**Department of Transportation
Olympia, Washington 98504**

**SR 14
W Camas Slough Bridge Deck
Paving
27x345 // XE3733**

Addendum No. 1

GENERAL NOTES SUGGESTED CONSTRUCTION SEQUENCE AND MEDIAN BARRIER AT ABUTMENTS 1 & 7

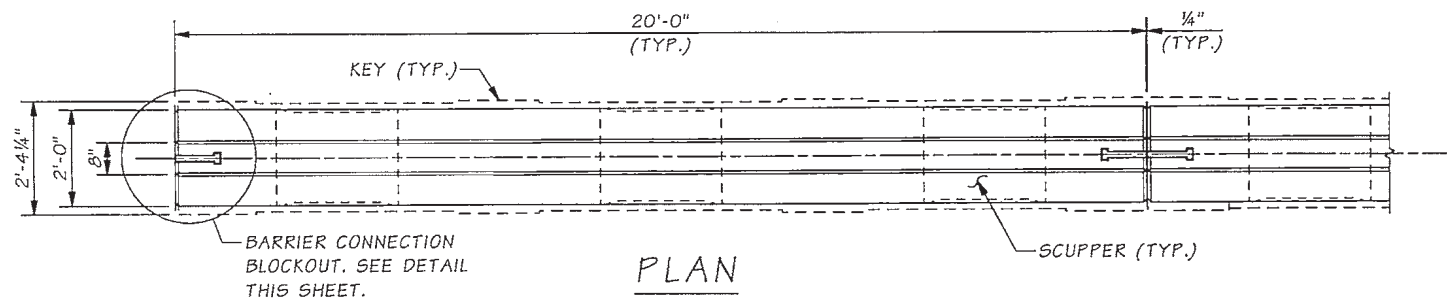
Plan Sheet #4A (CT1A1) is added.
Plan Sheet #11 (BG2) is revised as clouded and noted on the attached sheet.
